County of Santa Clara

FILE NUMBER: PLN20-134
SUBJECT: Building Site Approval, Design Review (Tier II), and Grading Approval Applications
SITE LOCATION: 3412 Fowler Road, San Jose (APN: 660-33-009)
DATE RECEIVED: April 11, 2023

Your application for Building Site Approval, Design Review (Tier II), and Grading Approval was received on the above date and is deemed **incomplete**. For the application processing to resume, you must resolve the following issues and submit the information listed below.

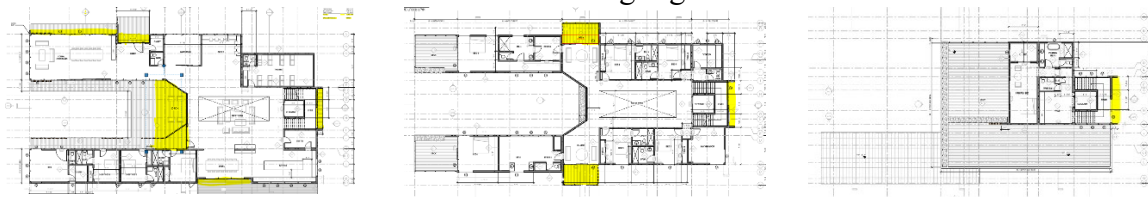
2. Legality verification of APN 660-33-009 is NOT established yet with the supplemental deeds submitted on 4/11/2023. Please submit recorded deed prior to June 25, 1969, with the same configuration with the current deed. This information is necessary to ensure that the lot in its current configuration was conveyed before 1969 and thereafter.

For future deeds resubmittal, please ensure the documents are complete with no missing pages, and the deeds must be clearly readable. Please also provide the book and page number of the document if that information was not shown on the document itself. Please mark / note on the deed if it involved more than one parcel. You may consider of consulting a surveyor for the interpretation of the legal descriptions.
